SITE PLAN REVIEW PLANNER'S TECHNICAL REPORT

9141-9143 Greenhouse Rd., Bentonville AR 72712

Ross Bull, applicant and property owner for Straightline Automotive, is proposing to construct a 3,330 sf commercial structure, in which 2,580 sf +/- would be used for a 6x bay automotive repair shop, with the remaining 750 sf used for office / administrative functions for the business. The property is currently improved with an existing, 1,684 sf dwelling, and an existing 684 sf accessory building. The accessory building would be used as part of the business, but for storage purposes only. Primary vehicular access is provided via an existing asphalt drive extending westward from the public ROW (Greenhouse Rd) to the existing dwelling. This drive would serve the proposed business, only, with vehicular access to the existing dwelling provided via a proposed secondary access point approximately 60 +/- ft. to the north of the current ingress/egress point. Sewerage would be disposed of via a temporary connection to the existing private septic system. Eventual connection to public sewer will be made via an extension line stemming from the adjacent subdivision now under construction.

SITE PLAN

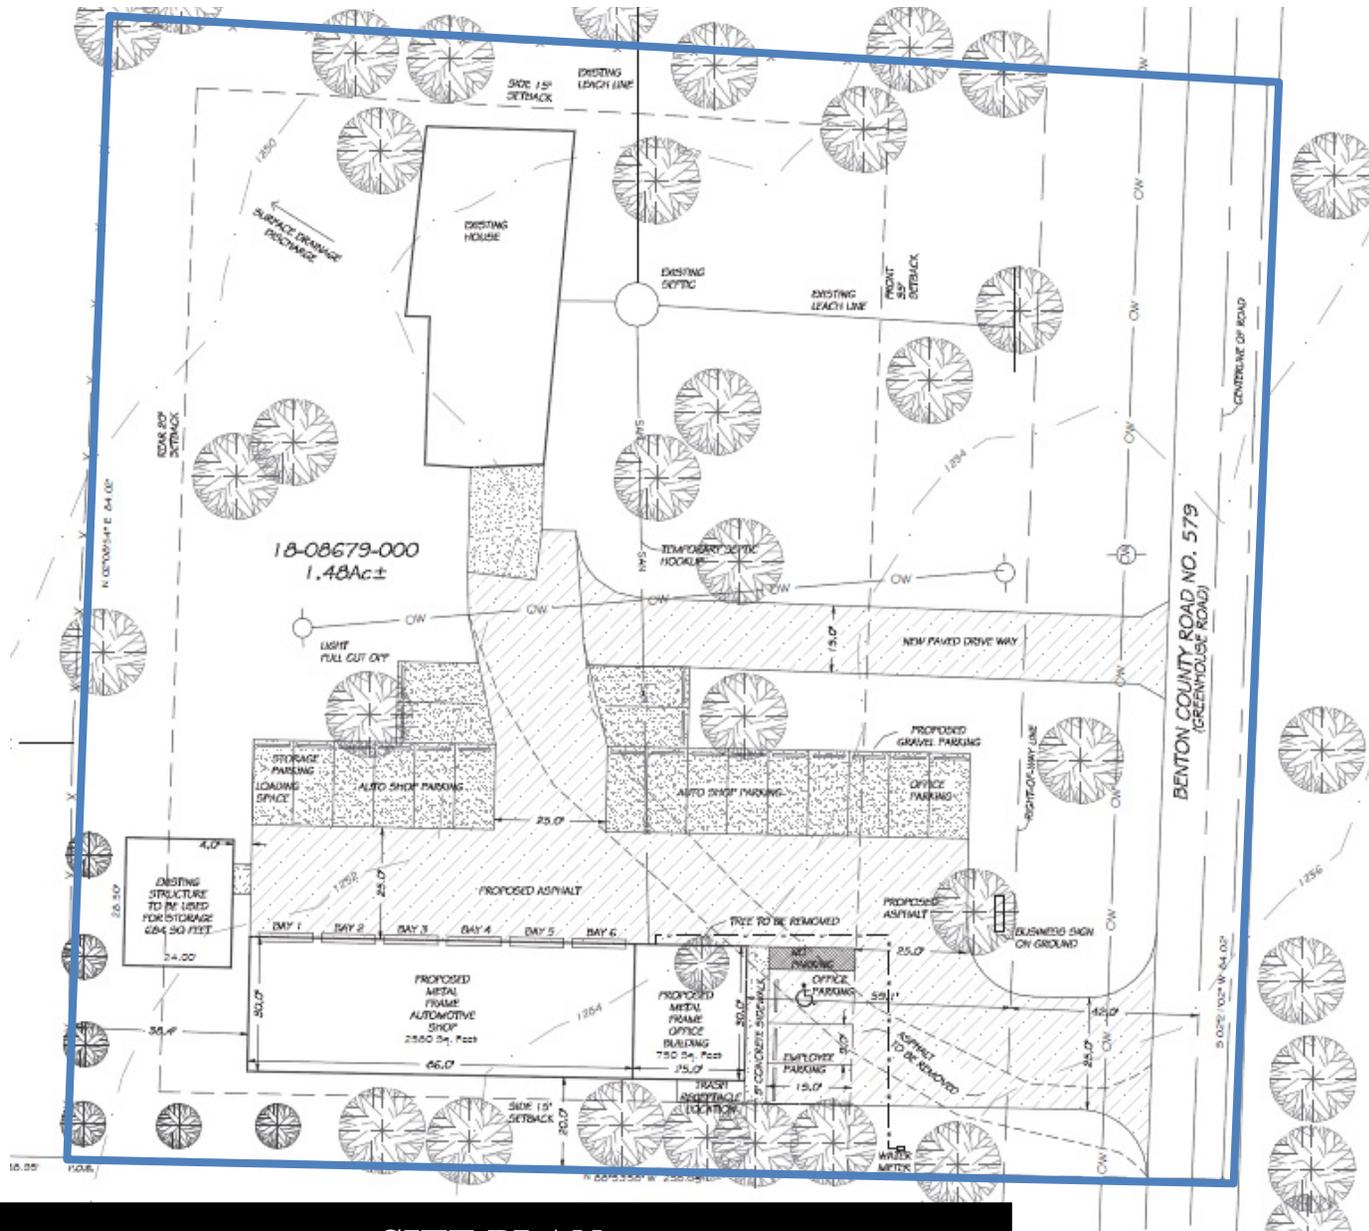
Comments: Site plans incorrectly apply current building to property line setbacks, and must be revised accordingly. All existing as well as the proposed buildings should either meet existing setback requirements or apply for a variance.

Comment: Applicant must revise 'site parking data table' as follows; 1.) Remove 'other commercial & retail' calculation, 2.) Correct parking calculation for the 'automotive shop' using 1 space per employee + 3 spaces per vehicle bay, 3.) Correct parking calculation for the 'storage' using 'warehouse or storage facilities' calculation of 5 spaces per 2000 sf of GFA, 4.) Re-calculate total parking spaces required, 5.) Notate number of parking spaces provided; 7.) Notate on lower portion of table the need for any parking variances based upon differences between required and provided parking spaces. Based on the required parking and proposed uses for the site, the total number of required standard parking spaces is 24, whereas the applicant currently shows 22 on the site plans submitted. The applicant has applied for a variance to allow 22 spaces in lieu of the required 24 spaces. The site shows 1 ADA accessible space as is required for site with less than 25 required standard spaces.

Current loading space is shown as having dimensions of 9ft in width and 19ft in depth. Loading spaces are required to be a minimum of 10ft by 25ft and should be revised accordingly on the site plans.

Comment: All exterior lighting on-site associated with the proposed structure shall be of a zero/full cut-off variety. Site plan show/note single, pole mounted lighting fixture to be converted to full-cutoff.

Comment: Land Use Compatibility analysis, per sec. 6.7, shows that the proposed use is classified as 'heavy commercial', and is immediately adjacent to single-family residential (medium density) land uses to the north, south, and west. This places the proposed use as being 'not compatible', and as such, will require mitigation efforts in order to buffer the proposed automotive repair shop. Specifically, table 6.6 (Compatibility Levels and Criteria) requires greater than 20 ft. of setback and may require 3 tier plantings as well as fencing.

Current site plans show the location of the existing dumpster adjacent to and to the rear of the proposed building. Applicant shall screen this enclosure as part of the larger, level 3 buffering requirements stipulated under the land use compatibility chart.

1. Site Plan revisions to include the following: Revise 'site parking data table' as follows; 1.) Remove 'other commercial & retail' calculation, 2.) Correct parking calculation for the 'automotive shop' using 1 space per employee + 3 spaces per vehicle bay, 3.) Correct parking calculation for the 'storage' using 'warehouse or storage facilities' calculation of 5 spaces per 2000 sf of GFA, 4.) Re-calculate total parking spaces required, 5.) Notate number of parking spaces provided; 7.) Notate on lower portion of table the need for any parking variances based upon differences between required and provided parking spaces; Revise dimensions for loading space to a minimum of 10ft by 25ft; Show inset detail showing required, level 3 compatibility buffering between proposed auto shop and surrounding residential uses; correct front, side, and rear building-to-property line set-back lines; amend 'general note' to include source of GIS topography data.
